RESOLUTION NO: 91-34  
A RESOLUTION OF THE CITY COUNCIL  
OF THE CITY OF EL PASO DE ROBLES  
APPROVING AN AMENDMENT TO DEVELOPMENT PLAN DETAILS  
FOR PLANNED DEVELOPMENT 90013  
(GRANARY ASSOCIATES)

WHEREAS, Granary Associates, have filed an application to amend development plans (previously approved via Resolution 90-202) for the construction of an approximate 24,000 square foot commercial/office center, located on the southwest corner of Riverside Avenue and 12th Street, and

PD 90013 (AMEND)  
 EXHIBIT F-1

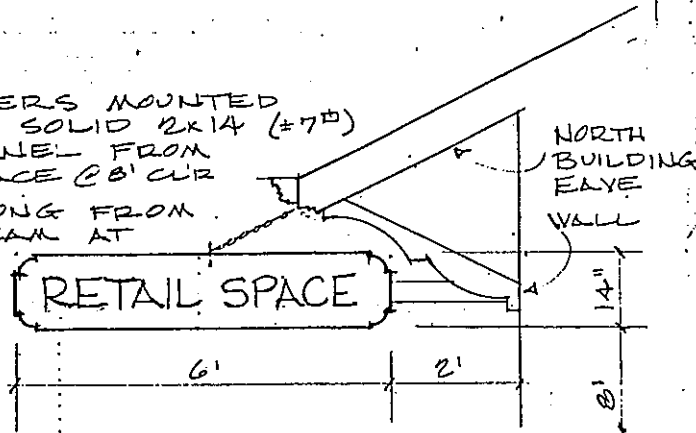
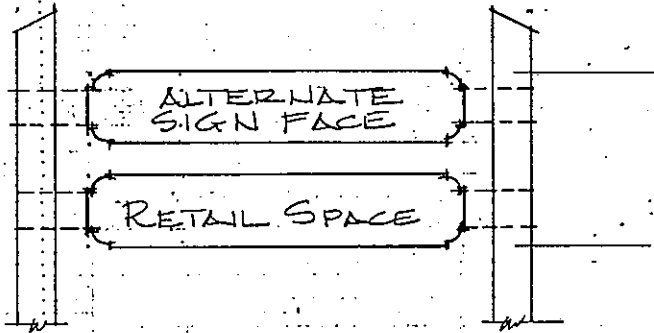
51. The developer shall redesign and relocate the sign shown on detail number 5 of exhibit F1 to be freestanding as the sign shown in detail number 6 of exhibit F2. Each sign shall be no higher than a total of 6 feet.
